Access Compliance Report

Public Rights-of-Way

(Curb Ramps)

Intersection ID: 10025333	Main Street: E_6TH_ST	Cross Street: N/A	Location: W
ADA ID: 334544E51950	Ramp Type: Perp	Initial Pass/Fail: Pass	Overall Compliance: No
Severity Score: 0.25			
Codes/Mitigation Info/Possible Solution		Field Measurements/Component Compliance

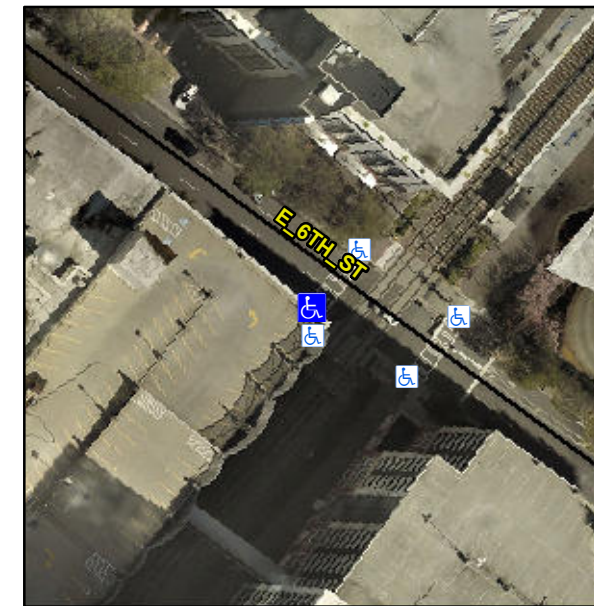
Not Found, R304.5.3, R304.2.2-Perp, R304.3.2-Para

Compliance	Description	Data	Compliance	Description	Data
N/A	Ramp Length (in)	51.0	Yes	Ramp Slope (%)	6.2
Yes	Ramp Width (in)	48.0	No	Ramp XSlope (%)	3.9
N/A	Flare Type LT	Sloped	N/A	Flare Type RT	N/A
N/A	Flare Slope LT (%)	3.7	Yes	Flare Slope RT (%)	0.1
N/A	Flare Traversable LT?	Yes	N/A	Flare Traversable RT?	Yes
Yes	Landing Length (in)	48.0	Yes	DWS Provided?	Yes
Yes	Landing Width (in)	48.0	Yes	DWS Contrast?	Yes
No	Landing Slope (%)	2.2	Yes	DWS Length (in)	24.0
No	Landing X Slope (%)	5.9	Yes	DWS Full Width?	Yes
N/A	Landing Curb? (Y/N)	No	Yes	DWS Offset (in)	2.0
N/A	Shared Landing?	No			
Yes	Gutter Ponding?	No	Yes	Gutter Slope (%)	1.7
Yes	Gutter Lip Ht (in)	0.0	Yes	Gutter X Slope (%)	1.9
N/A	Painted X Walk1?	Yes	N/A	Painted X Walk2?	N/A
	X Walk 1 Direction	To NE		X Walk 2 Direction	N/A
N/A	X Walk 1 Width (in)	112.0	N/A	X Walk 2 Width (in)	N/A
	X Walk 1 Slope (%)	1.3		X Walk 2 Slope (%)	N/A
	X Walk 1 X Slope (%)	1.0		X Walk 2 X Slope (%)	N/A

Remove & Replace Entire Ramp.
